HISTORIC DISTRICT COMMISSION NOTICE OF DENIAL

Application Number: HDC2026-00290

PROJECT ADDRESS: 1977 Atkinson St., Detroit, MI

Erect pre-fabricated metal building

SHEET. NO:
2 OF 7

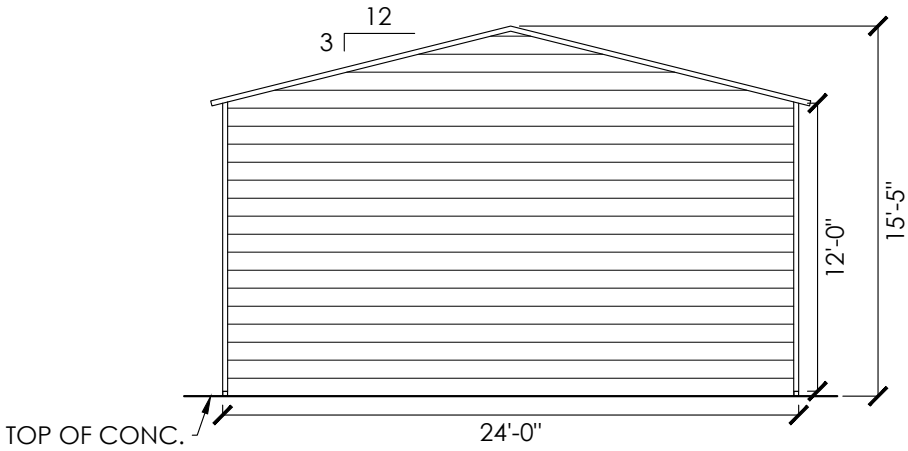
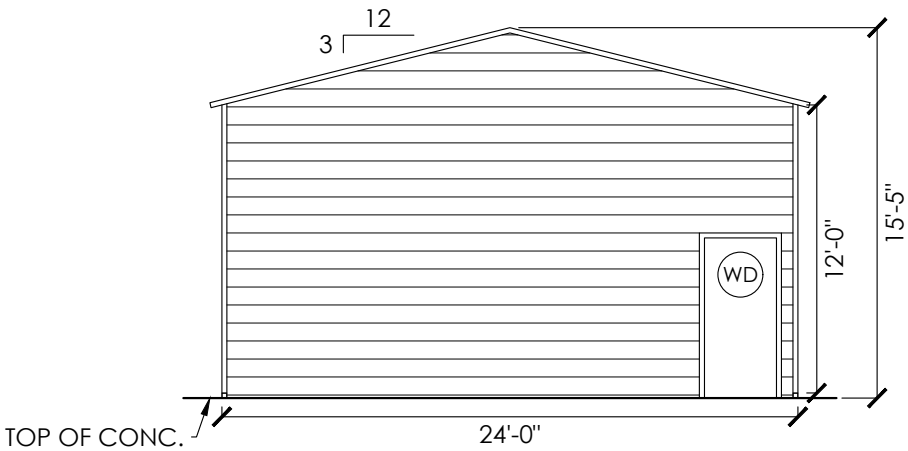
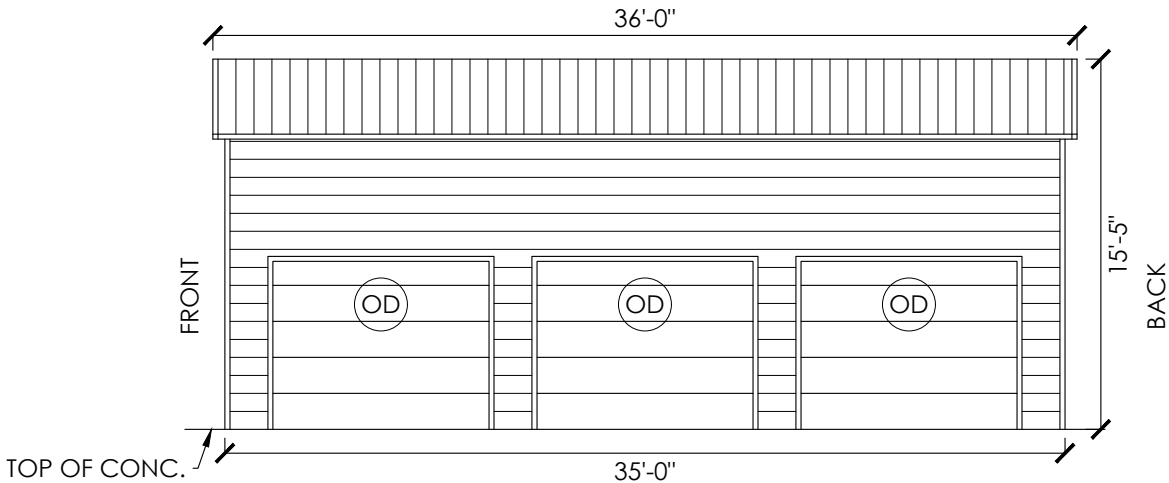
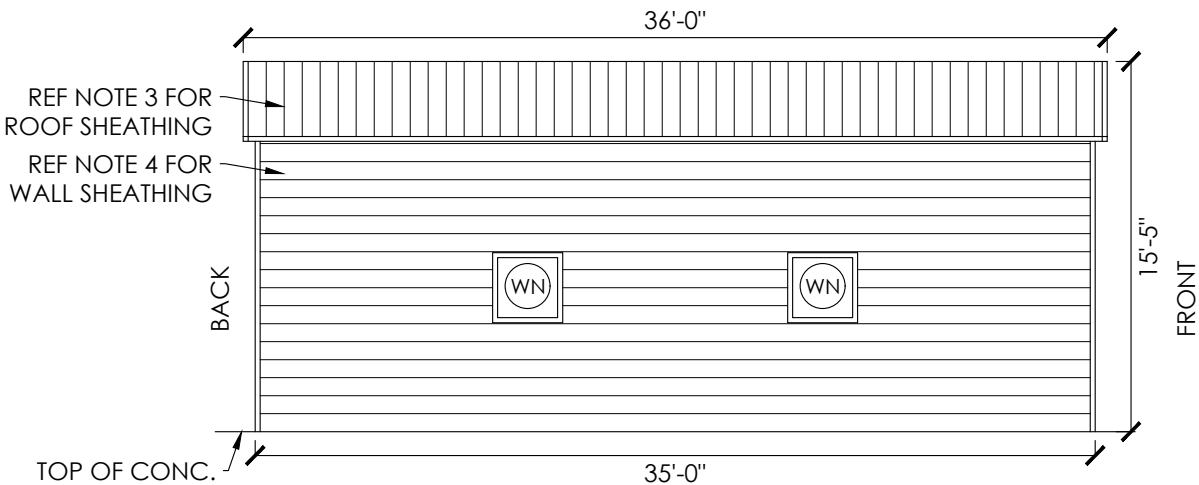
We don't see elevation drawings for your proposed garage with dimensions/measurements. We see that there is an elevation drawing that shows a maximum of 12' at the top of the wall. Elsewhere in the application materials, the building's height was listed as 9'. Will your garage have a wall height of 9'? How tall will the ridge/highest point of the garage be?
